Addendum No. 2

IFB-22-HHL-001

West O'ahu Sewer Improvements – Wai'anae Subdivision

Addendum No. 2
December 5, 2022

TYPE "A" PAVEMENT (CITY R-O-W)

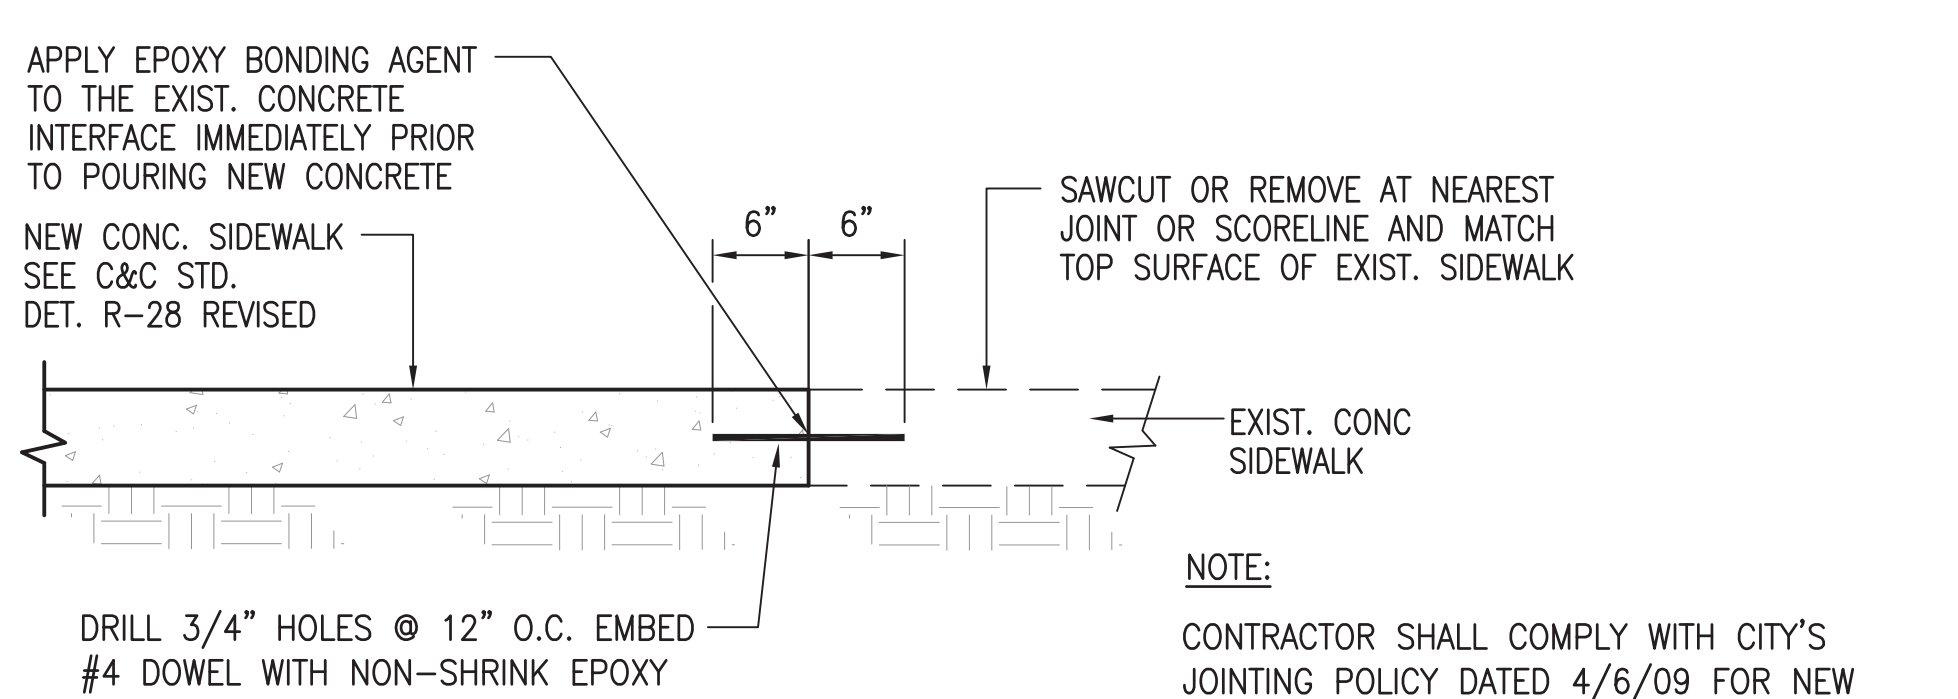
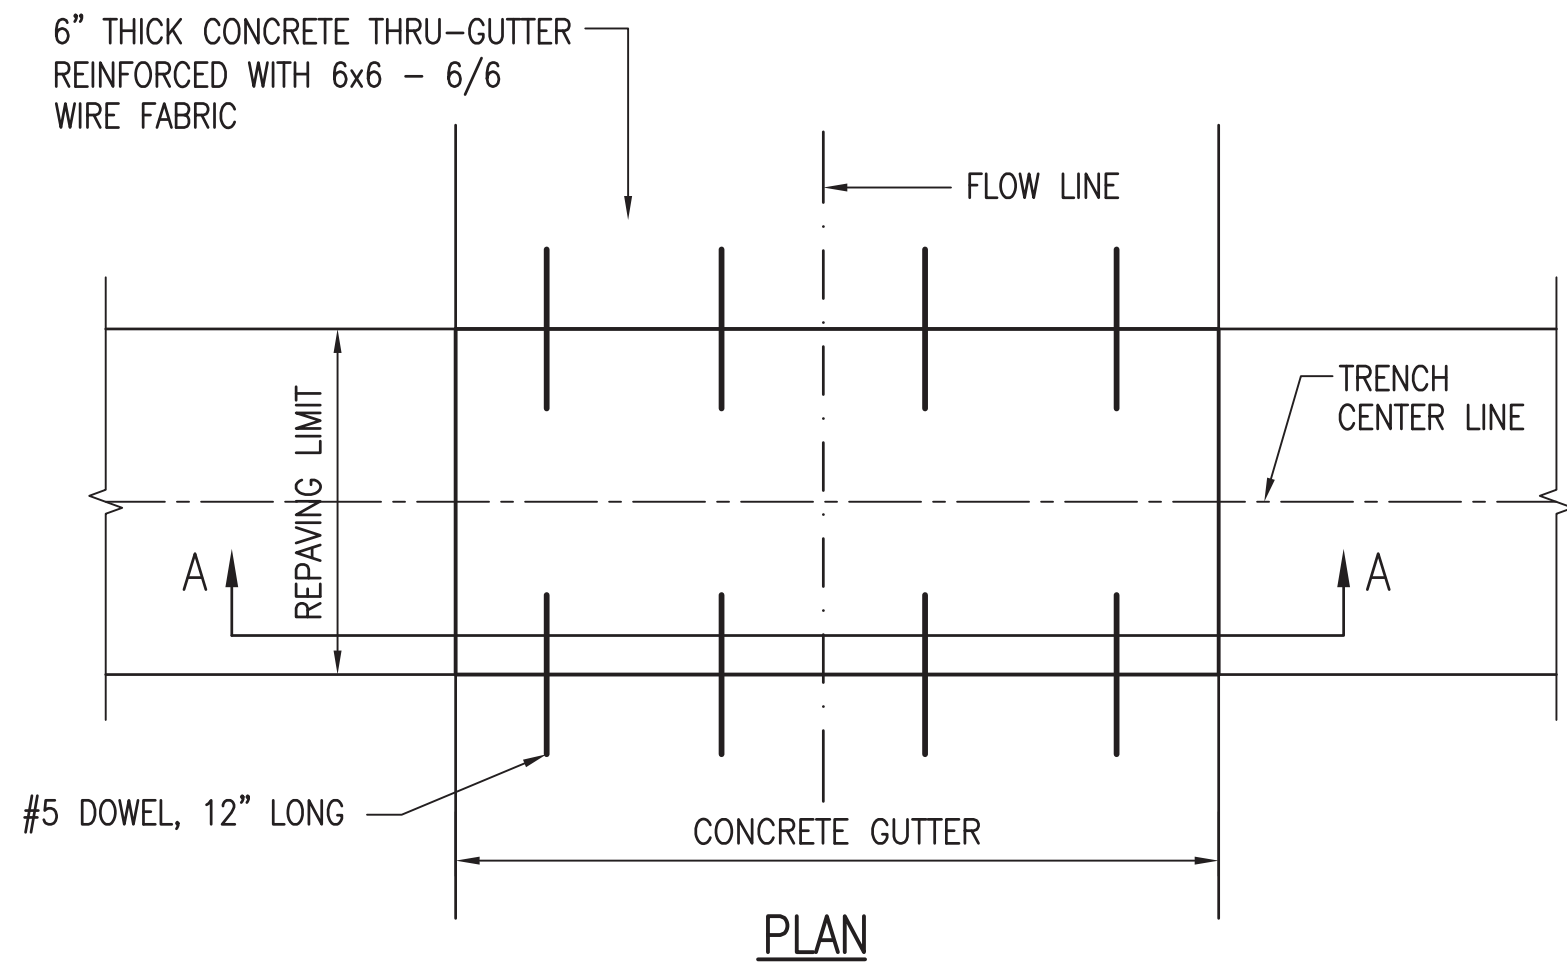
- Section 6 Plans, Sheet 41 of 84 - Revise Detail 3/C-32, from “4” MIN. ASPHALT TREATED BASE COURSE OR MATCH EXISTING WHICHEVER IS GREATER” to “6” ASPHALT TREATED BASE COURSE OR MATCH EXISTING WHICHEVER IS GREATER.” Revised Drawing C-32 (Plan Sheet 41 of 84) attached.
